PROJECT: Summerlin West Village 22 - Kettle Bend Road - Update #1
(Sunset Run Drive to Kestrel Creek Road)

SUBMITTAL: 3rd

CITY OF LAS VEGAS INTER-OFFICE MEMORANDUM			DATE: September 17, 2020
TO: **Land Development Services** Department of Building & Safety			FROM: Albert Sung, P.E. Flood Control Project Engineer Department of Public Works
SUBJECT: Drainage Study for: **Summerlin West Village 22 - Kettle Bend Road – Update #1 (Sunset Run Drive to Kestrel Creek Road)**			**COPIES TO:** VTN Nevada
Cross Streets:	Kettle Bend Road & Summerlin Parkway		The Howard Hughes Company, LLC
File Number:	F:\Depot\DSMemos\DS5204E.doc		Bart Anderson, P.E., DevCo
Parcel Number:	137-23-101-002		CCRFCD
Zoning Action:	N/A		
FEMA Flood Zone	YES	NO **X**	
Proposed Storm Drain	YES **X**	NO

3rd Submittal: Update #1 to package the portion of 8'x8' RCB west of I-215 from Summerlin West V21 Summerlin Parkway Extension Project to the subject Kettle Bend Road (Sunset Run Drive to Kestrel Creek Road) Improvement Project

SHEET
UT5
48 OF 131 SHEETS
DRAWING NO.

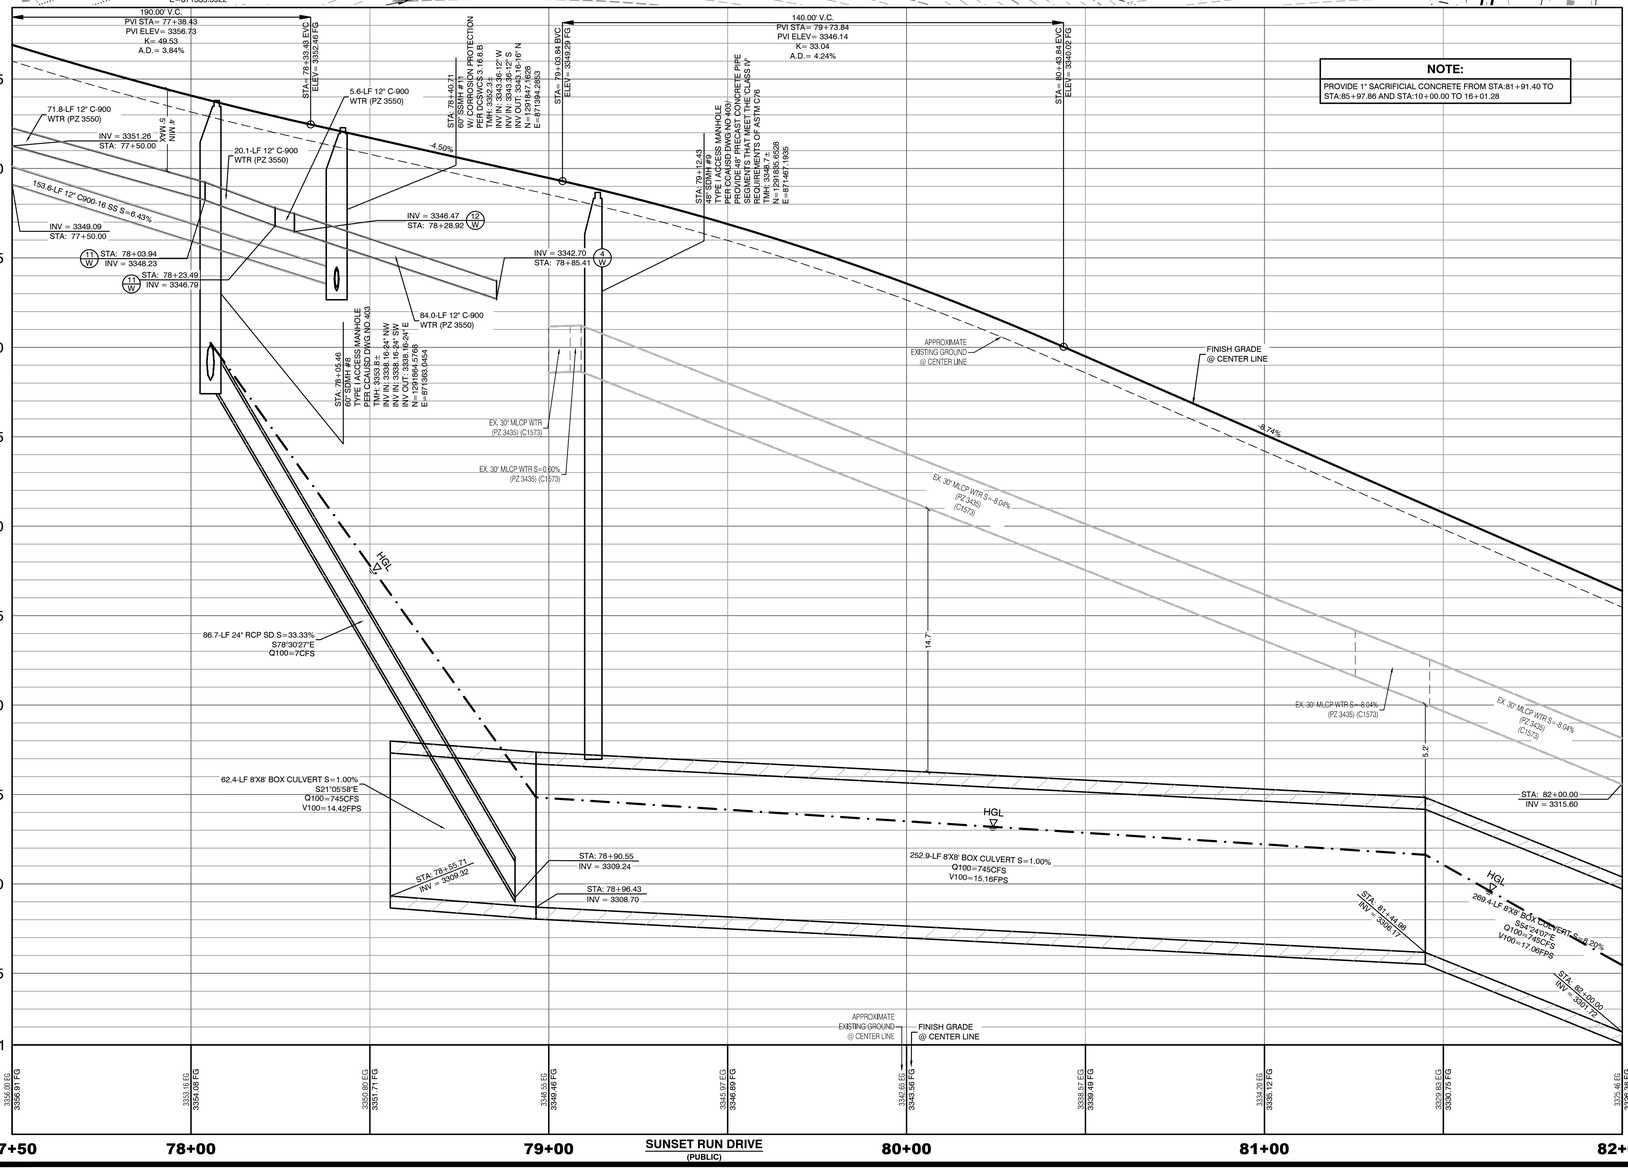
Sheet UT1 to Sheet UT5: *The regional facility 8'x8' RCB in Sunset Run Drive is too close to the northern curb. In case of needing repair and maintenance in the future, the staging area will break into the curb area which is costly and problematic. Relocate the RCB to the center of the street as far as possible.*

The response was to maintain the original proposed location for the proposed regional facility 8'x8' RCB in *Sunset Run Drive*.

In the final map, dedicate the amenity zone behind the northern curb of *Sunset Run Drive* and east of *Kettle Bend Road* as a Public Drainage Easement to be Privately Maintained by the *Summerlin Master HOA*.

SHEET
UT6
49 OF **131** SHEETS

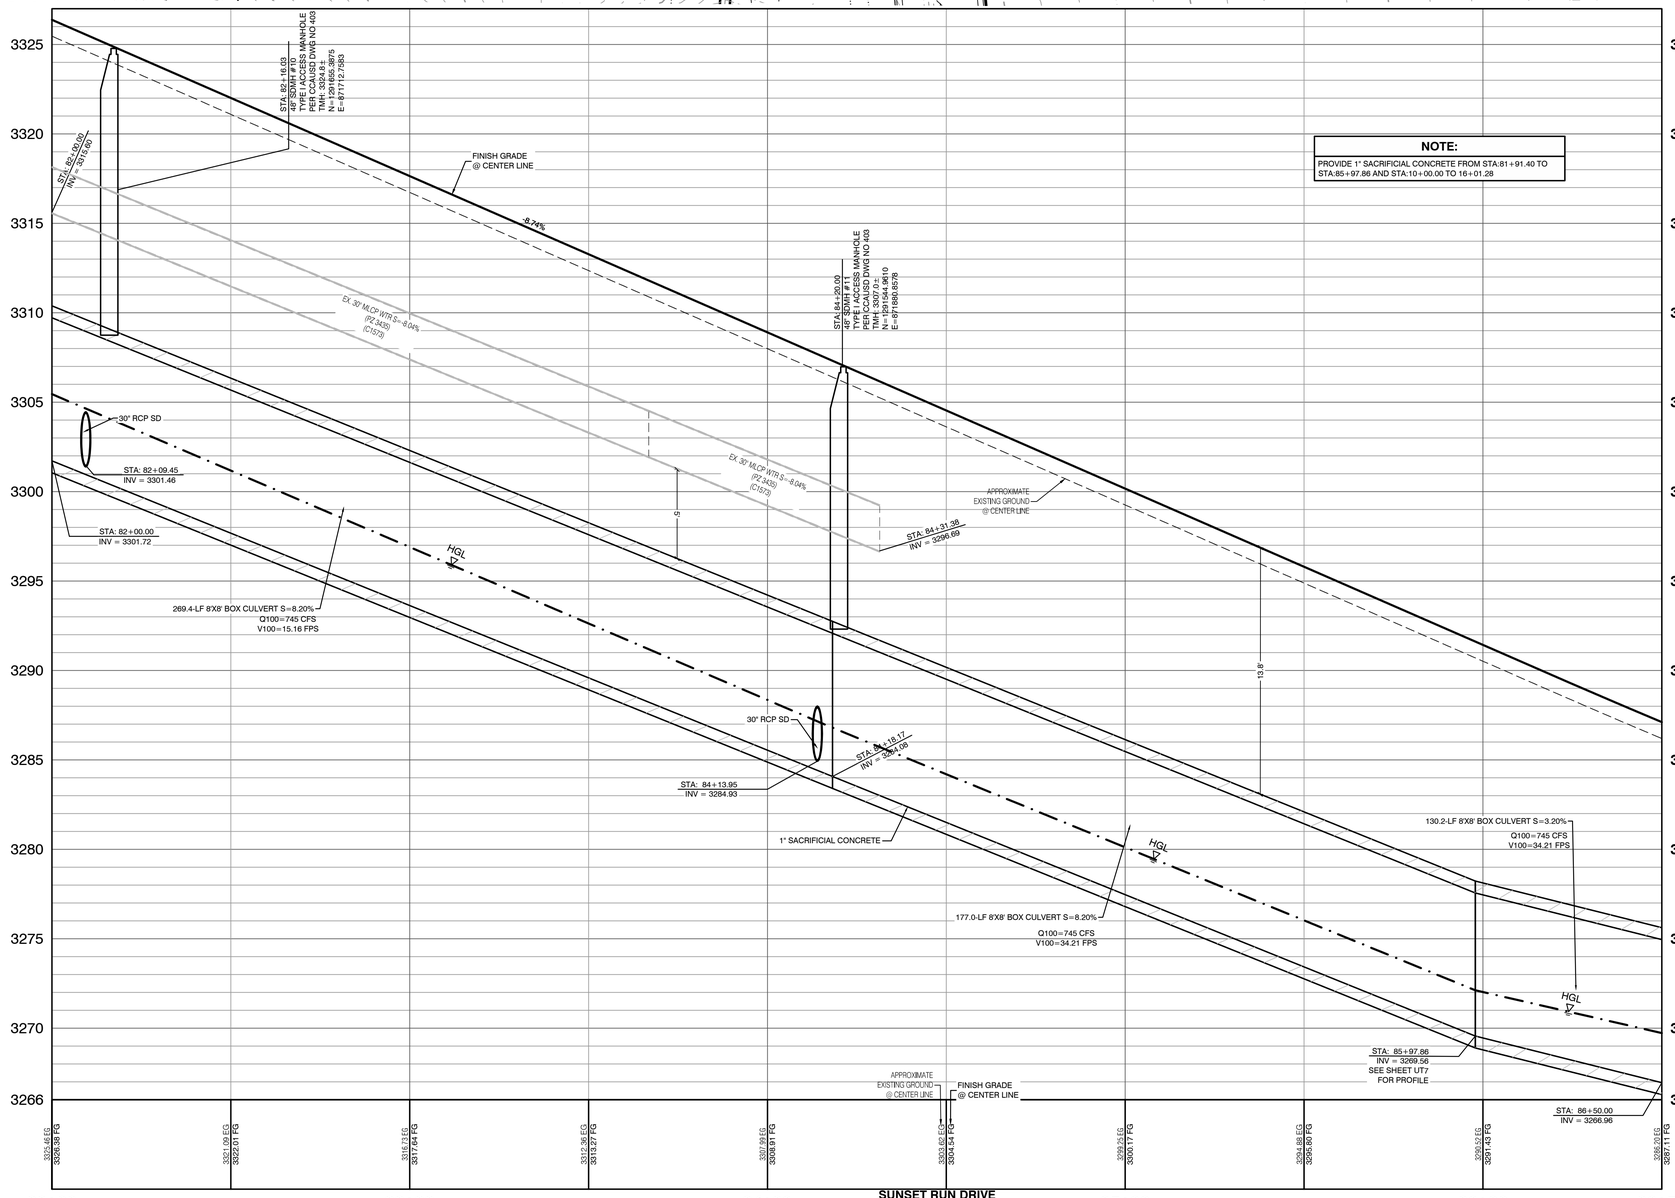
6. **Previous Comment #12: *Sheet GR5 to Sheet GR7 and Sheet UT5 to Sheet UT7****: The regional facility 8'x8' RCB in Sunset Run Drive is too close to the northern curb. In case of needing repair and maintenance in the future, the staging area will break into the curb area which is costly and problematic. Relocate the RCB to the center of the street as far as possible.*

The response is to maintain the original proposed location for the proposed regional facility 8'x8' RCB in *Sunset Run Drive*.
